LIGO-E1100050-v5

Responses to ACB FDR Questions

This document presents the answers to the AOS SLC Arm Cavity Baffle design review committee. The questions were posed in M1100009-v1.

Figure 4: TM Wide Angle Scatter, re-scattered by ACB surfaces

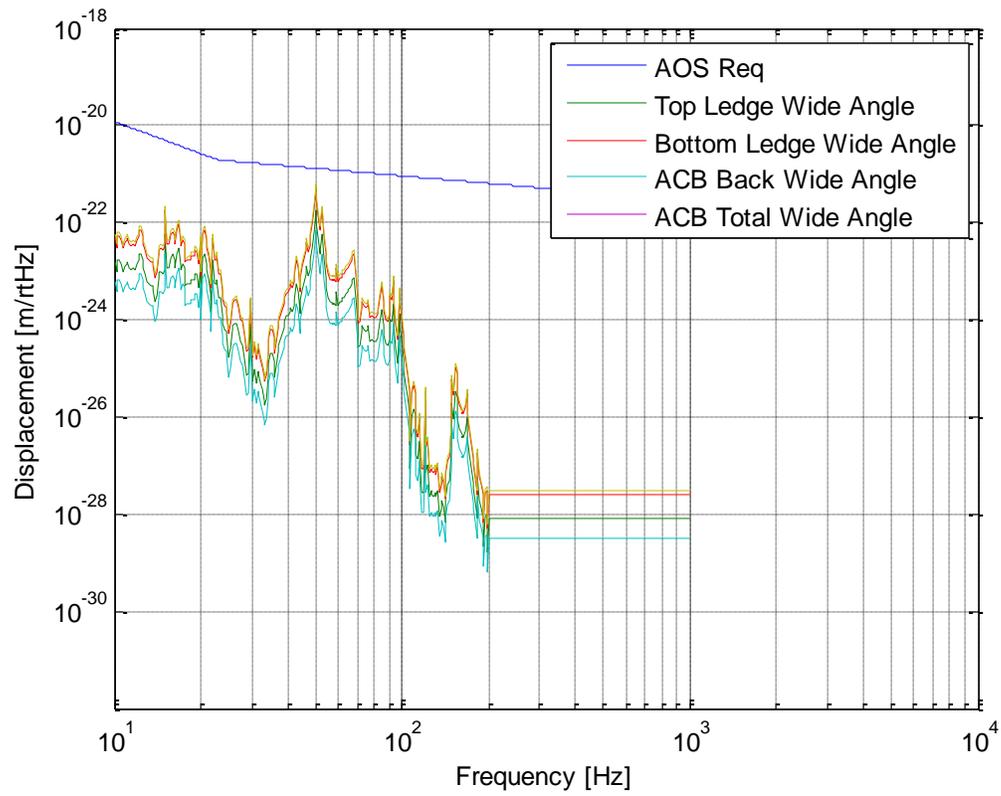
The new photodiode hardware on the back of the baffle, which has shiny components such as silver plated screws, should be checked to be sure that diffuse large angle scattering is not a problem, or it should be covered with a baffle. To prevent specular reflections we should watch for surfaces on the back side of the baffle that are nearly normal to a radius from the center of the optic face (such as the PEEK backs of the photodiodes and the edges of the shelves).

A ZEMAX simulation of diffuse scattering from the surface of the ITM showed that no specularly reflected rays will return to the COC mirror. The diffuse scattering from the Peek and from the cabling does not cause excessive displacement noise, as shown in Figure 4.

Figure 5: TM Wide Angle Scatter, re-scattered from Chamber Walls and Manifold

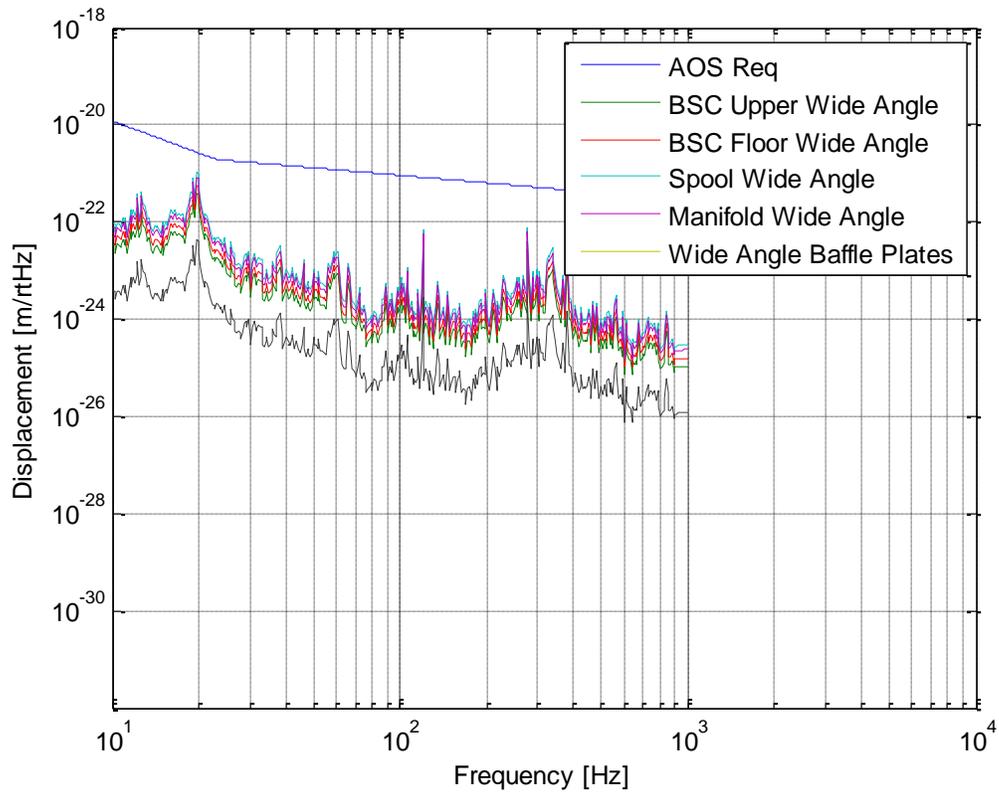
Are there any clear paths between the center of the optic face and the table that are not blocked by the baffle (especially since the top shelf is short)? I worry about this for large angle scattering.

The Lambertian scattering from the H1 ITMX HR surface was analyzed with ZEMAX ray tracing. The table below summarizes the fractional power hitting each of the surfaces listed. A pictorial view of the wide angle scattered light is shown in . The light that is not caught by the ACB baffle and the upper and lower ledges, 1) hits the upper and lower portions of the BSC, 2) is caught by the wide angle baffle plates, 3) passes through the BSC flange and hits the adjacent spool piece, and 4) the remainder of the light passes into the following BSC chamber or into the manifold (for L1 and H2). The calculated displacement noise cause by re-scattering from each of the listed surfaces is shown in Figure 4 and Figure 5

No, see Figure 4 and Figure 5

Figure 6: ZEMAX Lambertian Scatter Ray Trace from H1 ITMX HR, Top View

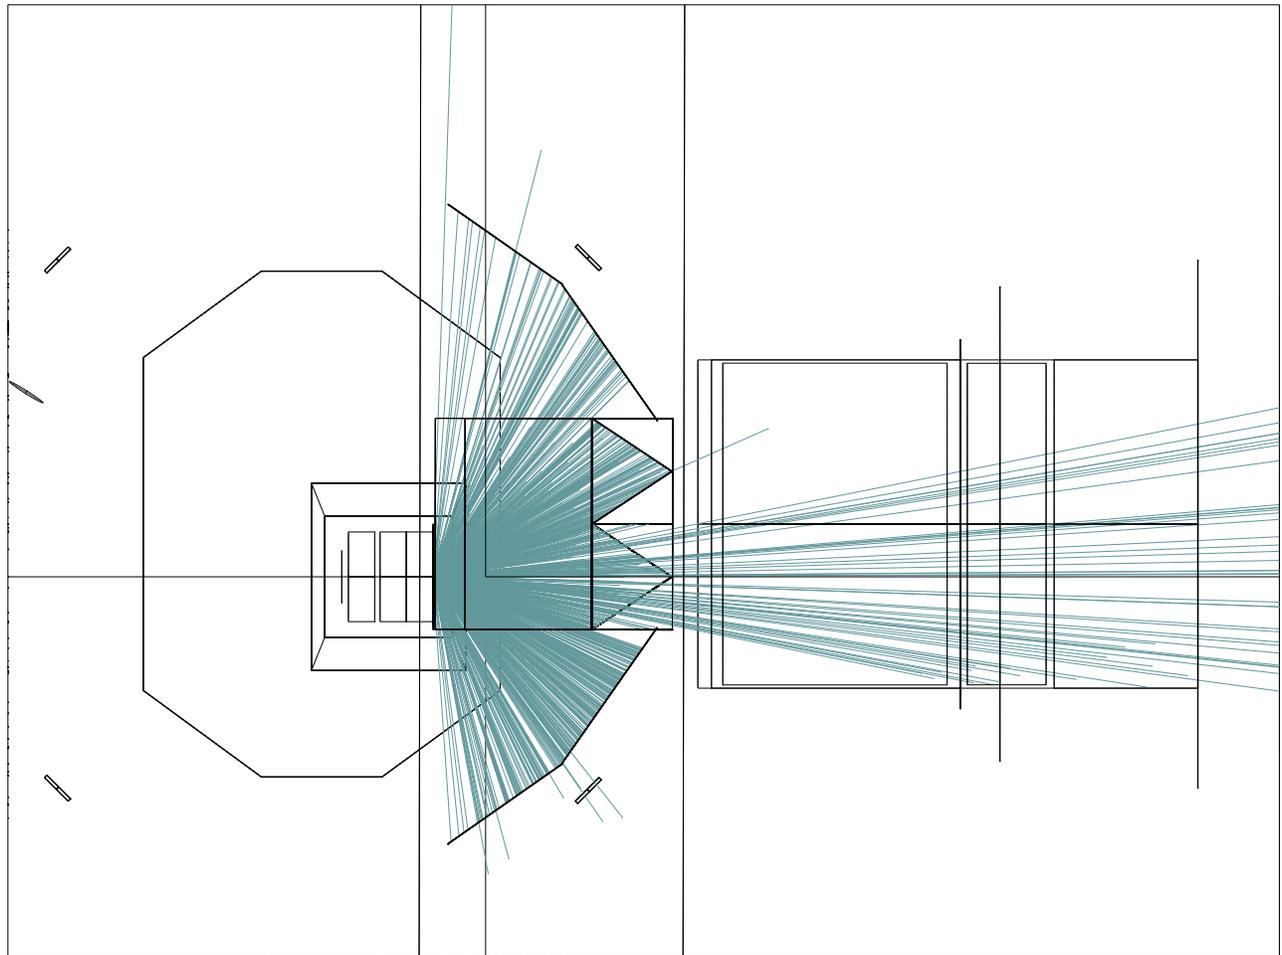
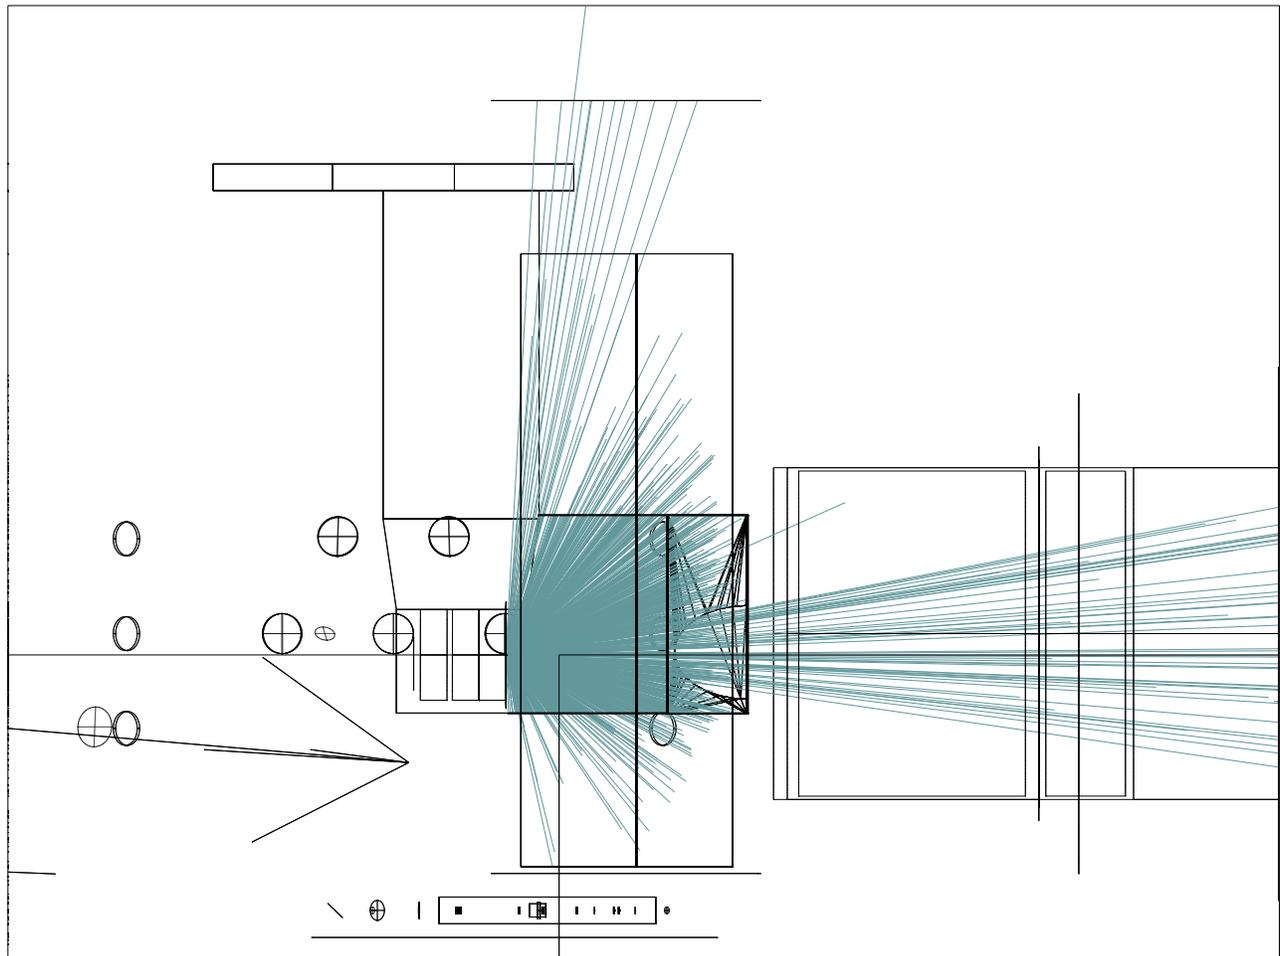
b) Do we need to increase the size of the "shark fins"? This should not impact SOW / RFQ prep. So recommendation is to leave design as is for now for RFQ and can switch out before PO placed if required.

Yes, the upper and lower wide angle scatter ledges will have extender shelves to bring the ledges as close to the TM as possible.

Figure 9: SUS Wide Angle Scatter

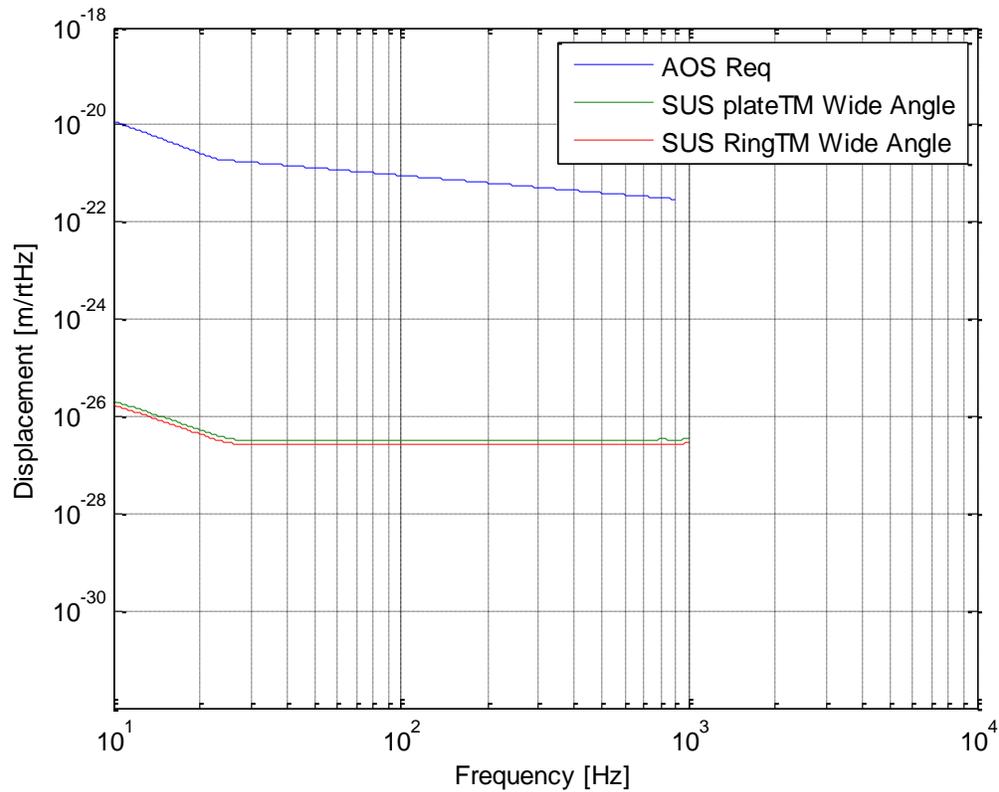
13) NEW QUESTION RE: WIDE ANGLE SCATTERING FROM THE SUS STRUCTURE

The quad SUS lower structure has an octagonal structural ring that surrounds the HR surface of the TM, which will catch some of the wide angle light scattered. A structural plate above the ring with an extended ledge will block the wide angle scattered light from hitting the upper stage of the SUS. The wide angle scattering displacement noise from the octagonal ring and ledge was calculated and are shown in Figure 9.

Figure 15: Clamping Detail for the ACB Top Mounting Plate

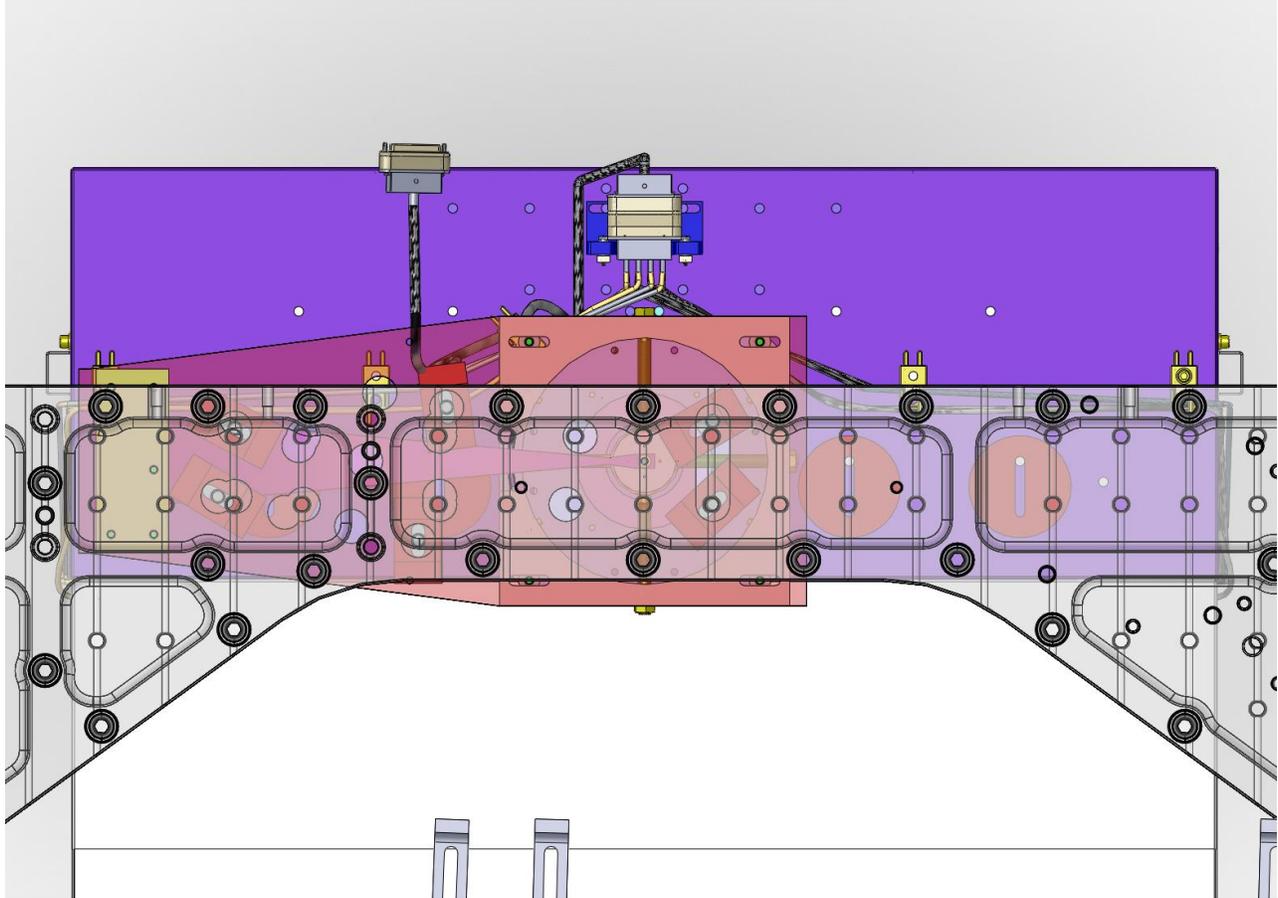
Clamping to stage 0. In T1000747 figures 18 and 20 are not consistent. Please work with systems to update the layout of all of the ACB wrt stage 0 to confirm clamping option proposed will in fact work.

A clear view of the clamping arrangement is in Figure 15.

Figure 16: ACB Shown Hanging with 3 Deg Tilt

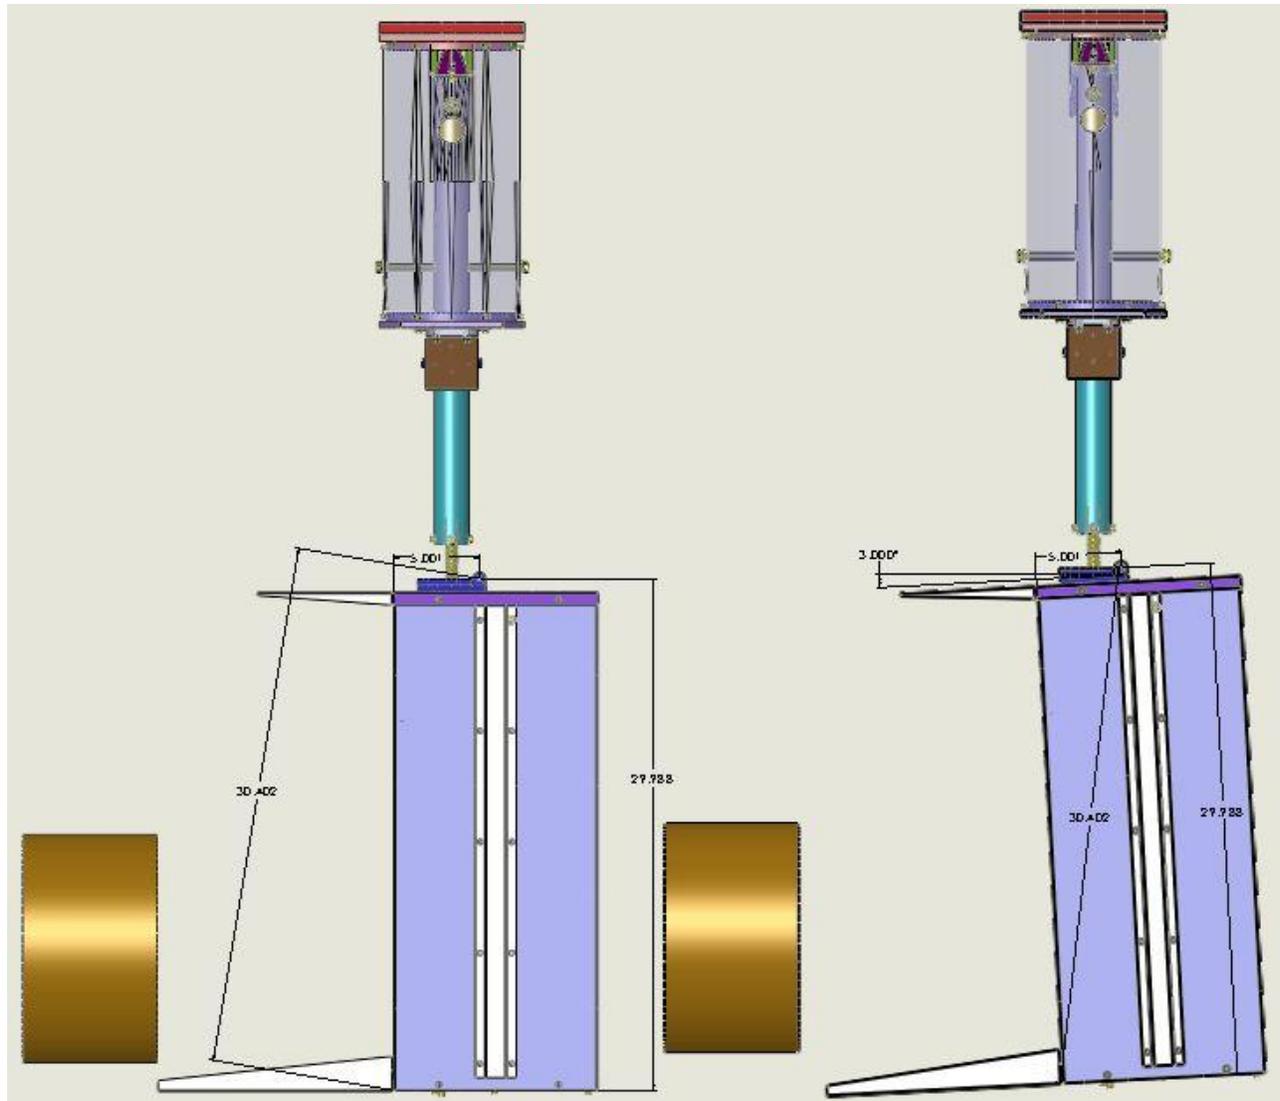
Do we have a glint line in the bend, apex of the V? ACTION - Analysis is required on this. Could a 5 deg tilt be included in design and would this be adequate?

14) ACTION on Mike Smith - Tilting BRDF - need to look at again? - URGENT!! Worried this could impact design.

I measured the BRDF of a typical porcelainized steel sample and calculated the glint from the baffle edges and apex bend using measured BRDF function. The edge glint is negligible when the baffle is tilted forward by 1 deg.

The present baffle design will be hung at a 3 deg tilt by placing a wedged washer between the hinge plates.
